# **Determination 2005/149**

# Refusal of a code compliance certificate for a building with a "log" weatherboard cladding system at 142 Princess Street, Waikeno, Waihi

Figure 1: Cladding profile showing lapped joint

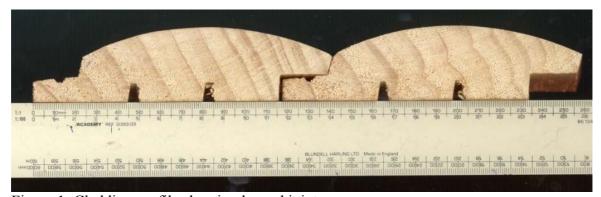
- 2.1.3 The wall cladding is a form of horizontal profiled timber weatherboard, with rebated lapped joints and a curved outer face that provides a "log" appearance. The weatherboards have a fully machined profile with overall dimensions of 141 mm x 34 mm (ref Figure 1). The laps are approximately 25 mm, with a close fitting joint along the bottom edge of the lapped joint that opens out to form a capillary break, the lap also has a small weathergroove in the under lap. The boards have a stain finish.

- 2.1.4 The weatherboard profile does not comply with the relevant sections of NZS 3604 or NZS 3617 or with Acceptable Solution E2/AS1. Accordingly I consider the weatherboard cladding, in the particular profile used on this house, to be an alternative solution (refer to paragraph 4.2).

- 3.2 In the application, the owner's agent stated that the matter of doubt was that the territorial authority:
  - ...require confirmation that one weather groove on the lap of the cladding is sufficient in order to grant final code of compliance certificate to the home.

- the external wall framing is likely to be treated to a level that provides some resistance to decay should the timber absorb and retain moisture.
- 6.3.3 The territorial authority questioned whether one weathergroove on the lap of the cladding would be sufficient to grant final code of compliance certificate to the home. The Building Industry Authority considered the absence of weathergrooves in weatherboards in Determination 2004/19. I have considered the comments made in that Determination and believe the following points are relevant:

- There will be cases where a capillary break can be achieved in another way (as is the case in bevel-backed weatherboards) and it may be unnecessary to machine additional grooves into the overlapping joint. In this instance there is one weathergroove provided plus the lapped joint opens out to provide a capillary break above the bottom tight joint.

- The cladding is thicker than the 19 mm specified for bevel-backed weatherboards in E2/AS1. The weatherboard is 34mm thick spanning studs at 600mm centres. The cladding is unlikely to deflect between supporting framing.

- 6.3.4 I believe these comments to be relevant in this particular case, and taking into account the factors described in 6.3.2 above, I decide that the absence of one weathergroove in the weatherboard cross-section does not render it noncompliant
